Contract Number 008066	Contract Title SR 520 Evergreen Point Floating Bridge and Landings	Federal Aid Number BR-0520(047)
Change Order Number 230	Change Description Anchor Cable Resolution	Date Jan 31, 2017
Region SR 520 Program	Project Engineer Robyn Boyd <i>RLB</i>	Phone Number (425) 576-7066
Prime Contractor / Design-Builder Kiewit/General/Manson. A Joint Venture (KGM)

**WASHINGTON STATE
DEPARTMENT OF TRANSPORTATION
CHANGE ORDER**

CONTRACT NO: 008066 FEDERAL AID NO: BR-0520(047)
 CONTRACT TITLE: SR 520 / I-5 TO MEDINA - EVERGREEN POINT FLOATING
 CHANGE ORDER NO: 230 ANCHOR CABLE RESOLUTION

Pontoon Anchor Cable Replacement Criteria:

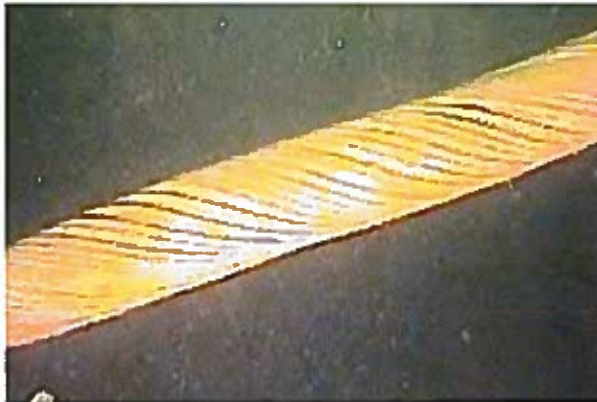
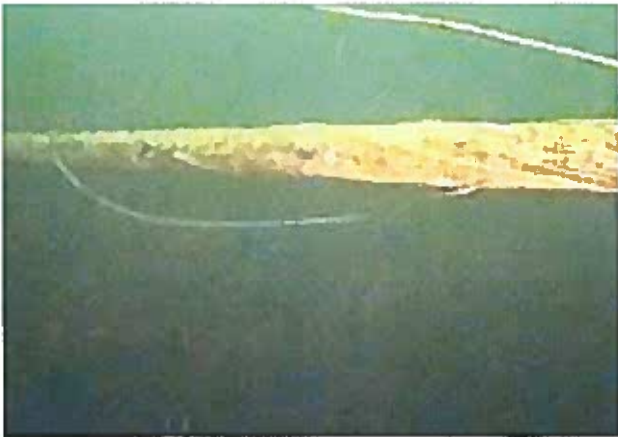
- An individual bend, twist, or kink.

- An individual deformity including basket, bird cage, or lantern distortion, or gaps exposing under wraps of the cable.

For the Pontoon anchor cables identified for replacement, WSDOT will consider new, installed anchor cables with any of the following damage as defective. All defective Pontoon anchor cables shall be removed and replaced.

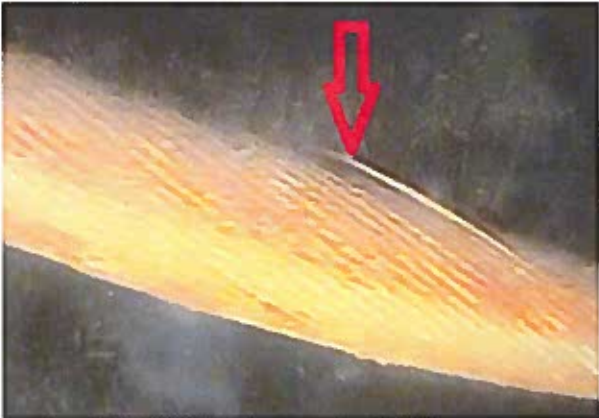
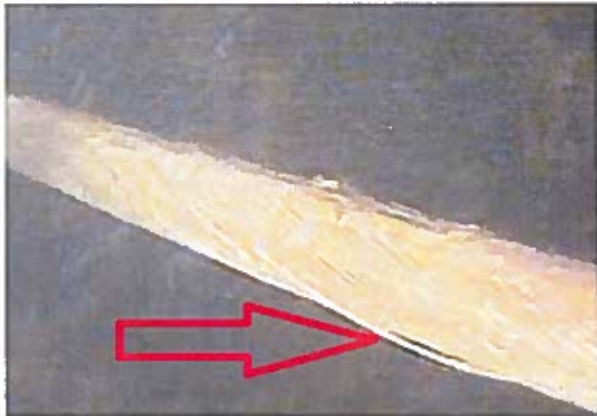
- An individual broken wire.

- An individual wire that is a full diameter or more out of lay.
